Access Compliance Report

Public Rights-of-Way

(Curb Ramps)

Intersection ID: 14071	Main Street: CLEVELAND_AV	Cross Street: E_KINGSTON_AV	Location: S
ADA ID: CFACD98E098C	Ramp Type: Directional1	Initial Pass/Fail: Fail	Overall Compliance: No
Codes/Mitigation Info/Possible Solution		Field Measurements/Component Compliance	
Severity Score: 13.75

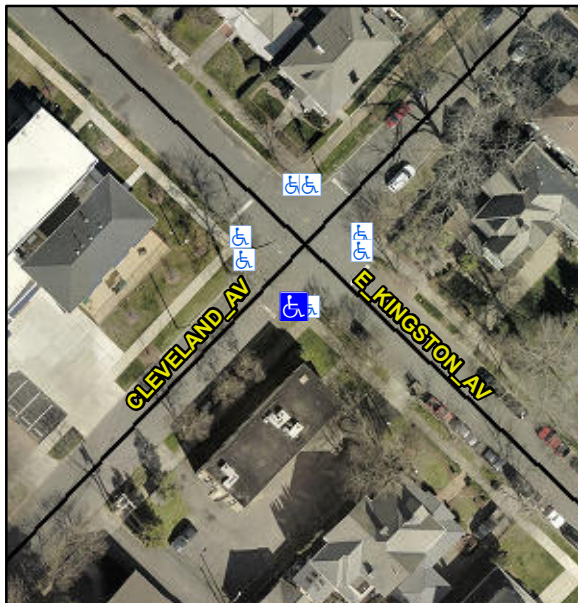
NO CURB LINE

PROW/ADA:

R304.2.2, R304.5.3

Remove & Replace Entire Ramp.
